**Re: Corrosion Control and Reservoir Roof - Plan Review # [119-2023](#)
Nestucca High School (PWS ID # 41-[90594](#))
Conditional Approval**

Thank you for your submittal to the Oregon Health Authority's Drinking Water Services (DWS) of plan review information for the *Nestucca High School Water System Improvements* consisting of corrosion control treatment (caustic soda) and a new reservoir roof for Nestucca High School's existing 3,500-gallon concrete reservoir. On August 30, 2023, our office received plans and specifications for the improvements. A plan review fee of \$825 was also received on September 1, 2023.

NESTUGCA HIGH SCHOOL
WATER SYSTEM IMPROVEMENTS
WS#: OR41 90594
TILLAMOOK COUNTY, OREGON
AUGUST 2023

PROPOSED WATER TREATMENT BUILDING SITE PLAN

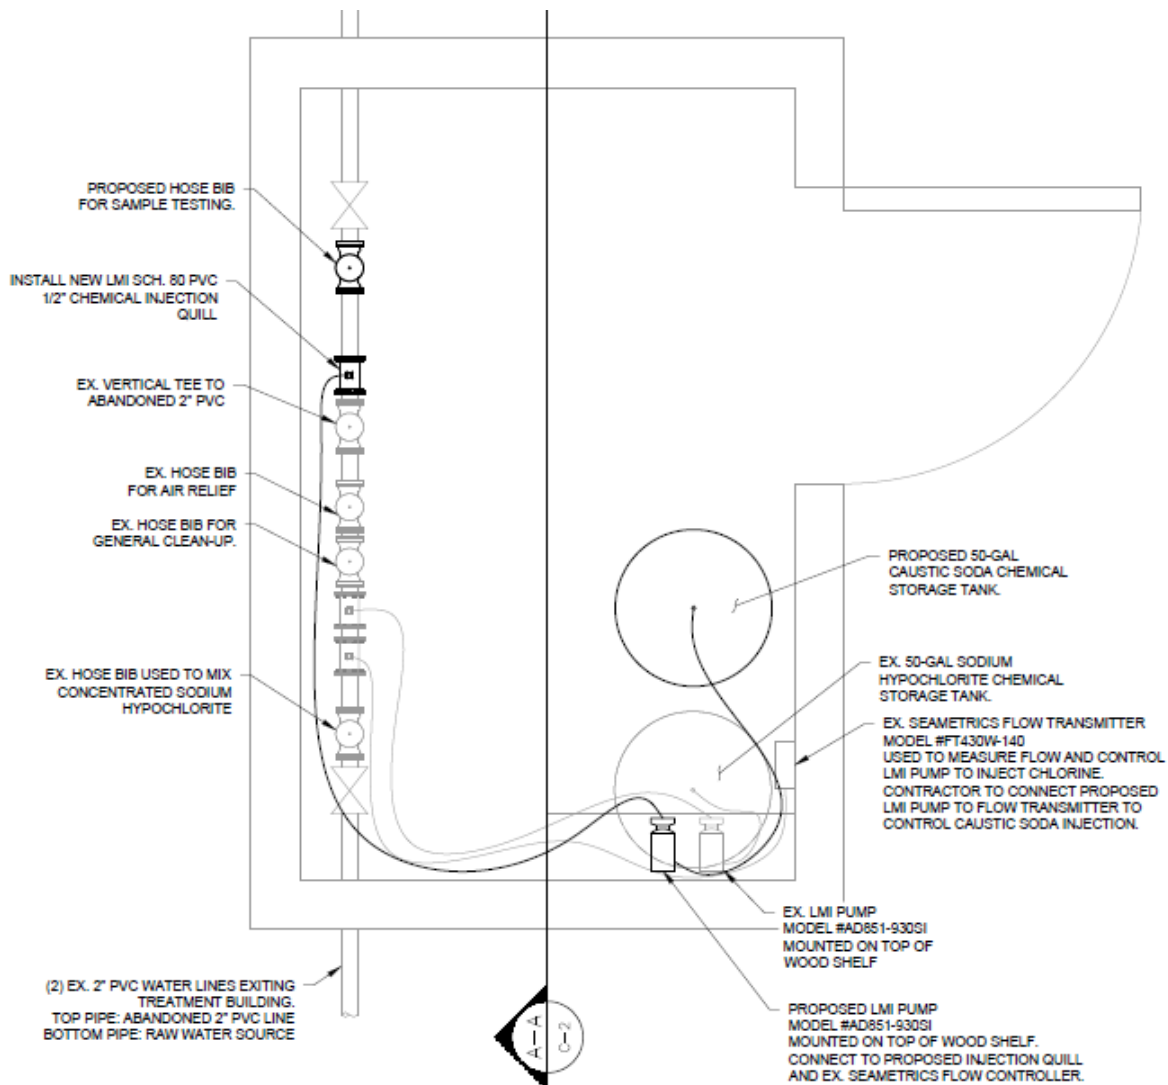
1. Product specifications need to be submitted showing the caustic soda meets ANSI/NSF Standard 60 for potable use - OAR 333-061-0050(1)(e).
2. The 50-gallon caustic soda tank must meet ANSI/NSF Standard 61 for potable use and is rated for use with caustic soda - OAR 333-061-0050(1)(e).
3. Plumbing is flushed, disinfected, and tested for coliform bacteria after construction and prior to use – OAR 333-061-0050(10). I have provided these requirements as an attachment to this letter (see pages 11-13).

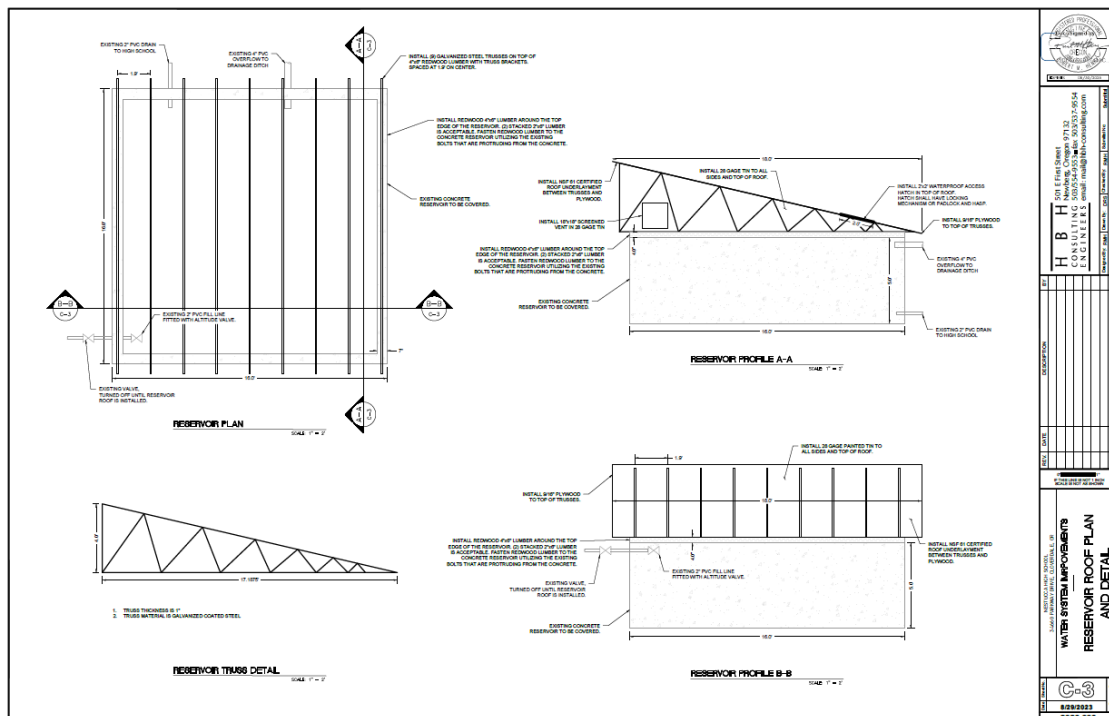
1. When the access manhole is on the roof of the reservoir there shall be a curbing around the opening (e.g., 4" curbing) and a lockable watertight cover that overlaps the curbing - OAR 333-061-0050(6)(a)(J).

2. The outlet ends of the drain and overflow shall be fitted with angle-flap valves or equivalent protection and shall discharge to a watercourse or storm drain capable of accommodating the flow with a vertical separation between the bottom of the pipe and top of the receiving body or structure - OAR 333-061-0050(6)(a)(M).

3. A silt stop shall be provided at the outlet pipe (e.g., an extension of the outlet (effluent) pipe terminating 6" above the floor of the reservoir) - OAR 333-061-0050(6)(a)(N).

- a) An NSF-61 sealant may be needed to seal any gaps between the redwood top plate and the top of the reservoir walls. Although there are likely many other options available, [Silkaflex®-1A](#) is one example of an NSF-60 sealant.

- b) The existing bolts used to fasten truss members and redwood top plate should be inspected for corrosion and to make sure they are securely in the concrete. Fasteners should be replaced if found to be corroded or loose.

- c) A heavier 26-gauge galvanized and/or painted steel metal roofing may be a more durable option than the 28-gauge roofing planned and will be better able to withstand wind, however I will defer to the design engineer's judgement. If 26-gauge roofing is chosen, the design of the roof trusses should be verified to ensure they can support the additional weight.

- d) A 24-mesh stainless steel insect screen for the reservoir vents is recommended. A coarser ¼" or ½" galvanized or stainless hardware cloth can be placed over the finer insect screen to protect the finer screen from damage.

- e) Installing a gutter on the downslope side of the roof with a downspout to divert rainwater will help minimize erosion and ponding around the base of the tank foundation.
